New York State Department of Environmental Conservation

October 26, 1998

Re: Lake Ontario Ordnance Works, Component 2 - Phase 1 Interim Removal Action

Photograph Locations

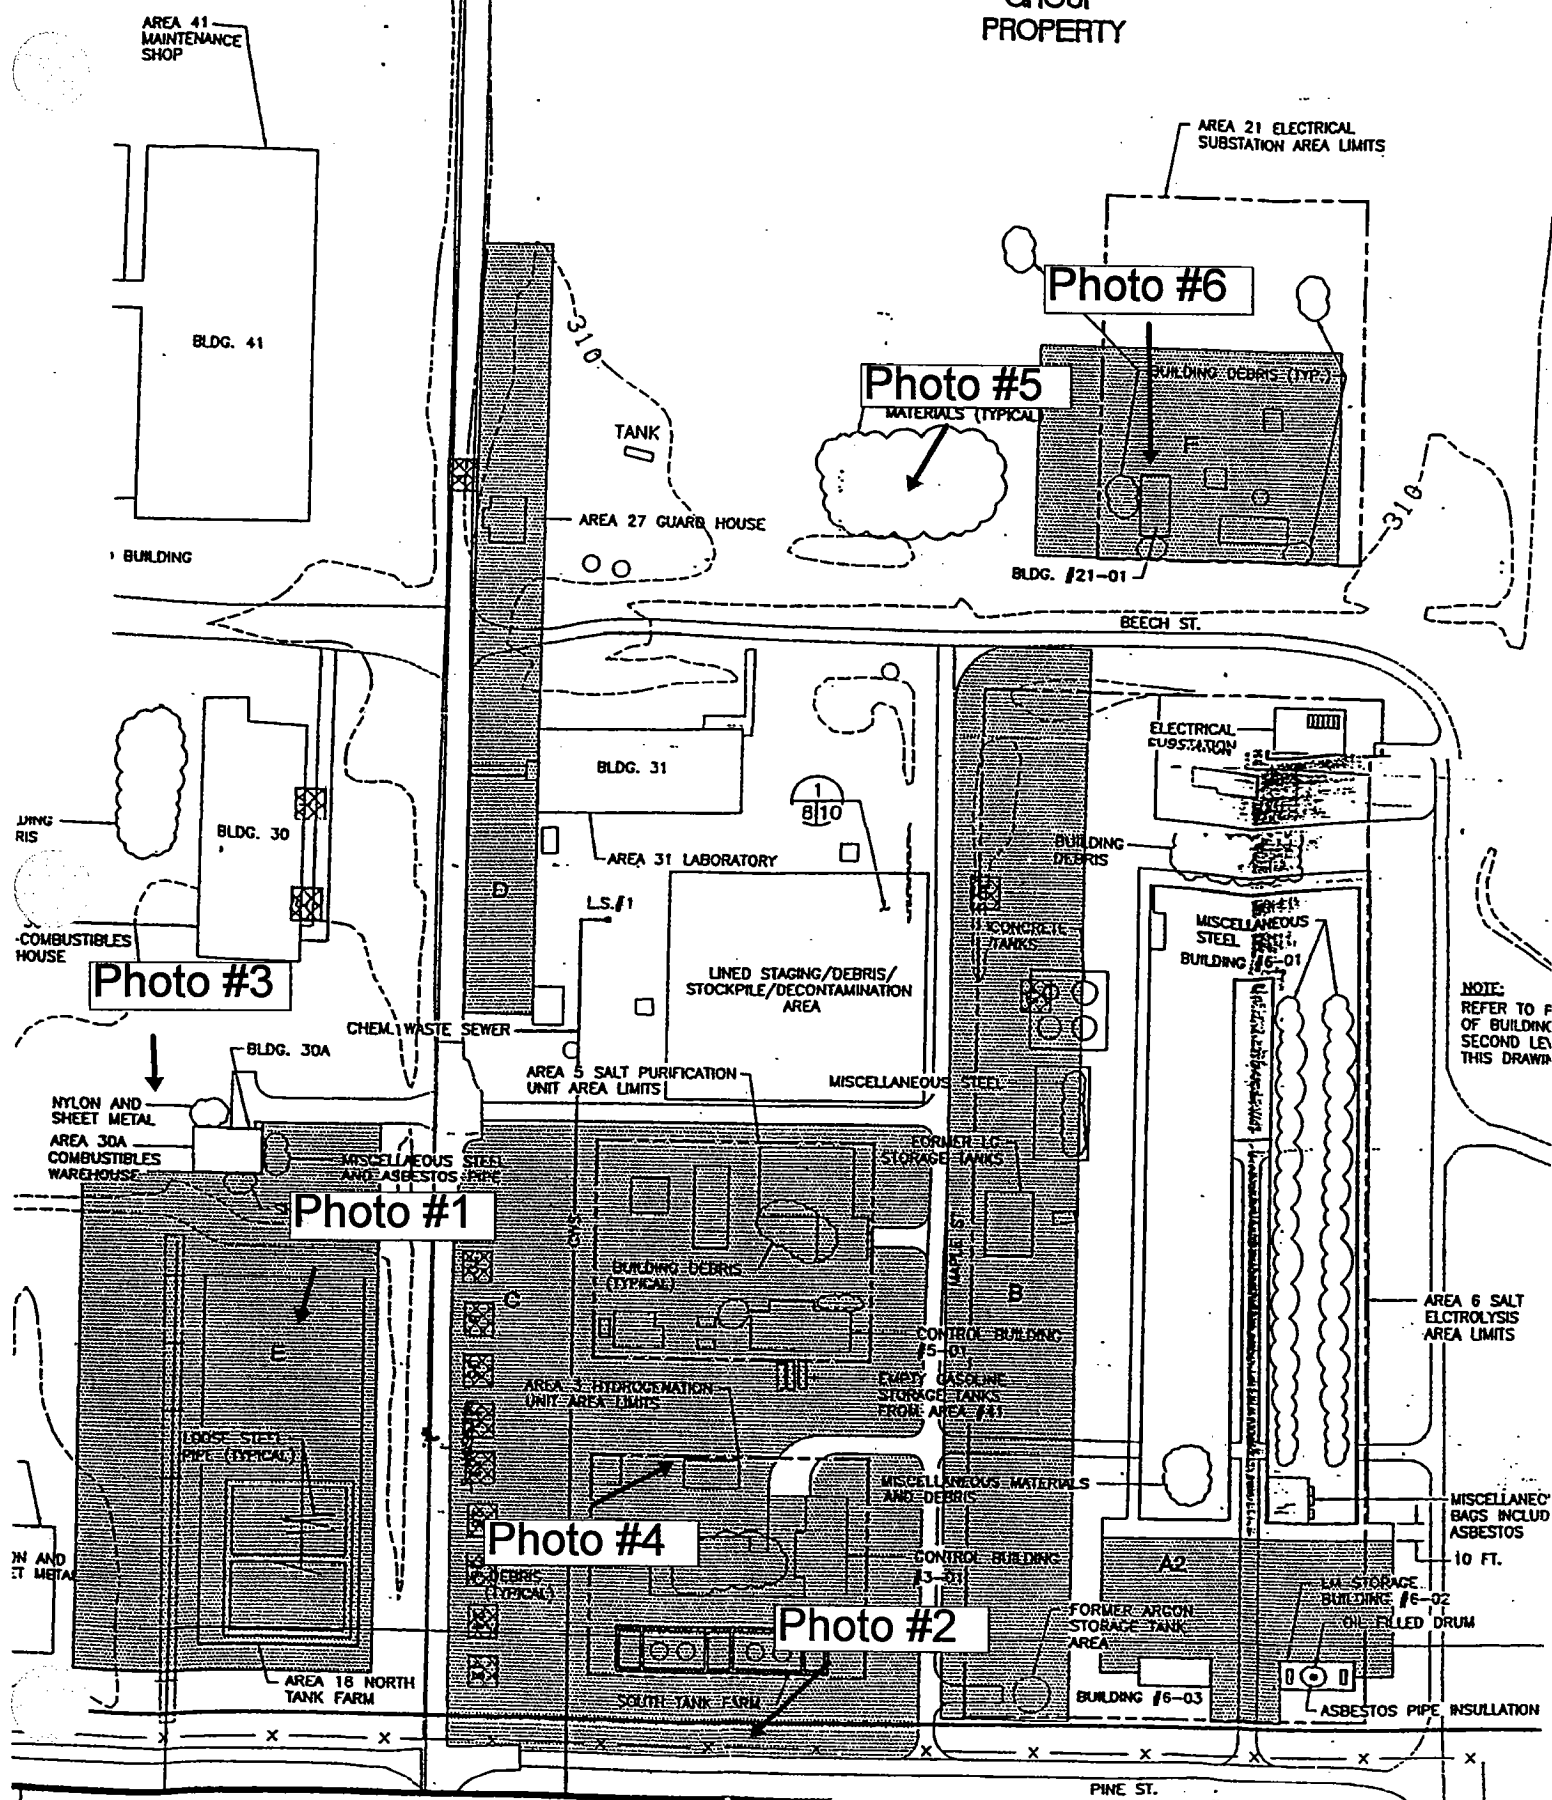
1. Pieces of potential asbestos containing materials (PACM) (pipe insulation, broken transite panel) were noted in areas which have been excavated (Photo # 1). Additional measures need to be taken to clean up areas which remain to be visually contaminated after excavation.
2. The depth of soil excavation is not a uniform 6 inches as called for in the specifications. Actual excavation depths ranged from <1" to 6". In order to assure that soils have been removed in accordance with the specified depths, the areas should be surveyed before and after excavation activities.
3. PACM was noted in areas beyond the proposed limits of excavation (south fence line) (Photo #2). The area of excavation should be expanded to the fence line, to address the impacted areas.

4. A debris pile, west of Building 30A (depicted on Plate 4 of the 100% Design Report and Photo #3) containing ACM pipe insulation needs to be addressed. This area must be adequately addressed.

6. Friable ACM was noted in soils scheduled to be excavated (Photos #3 & 4). The presence of friable ACM exposed to the elements increases the need for wetting down of areas prior to and during excavation. Additional measures may also be required for the abatement of degraded asbestos thermal insulation present on jacketed pipes within the excavation areas.

13. Building 21-01 (Photo #6), groundwater monitoring wells north of Area 18N and a fire hydrant west of Area 18 N (Excavation Area E) have been damaged by heavy equipment. Property damages caused by USACE contractors must be properly repaired.
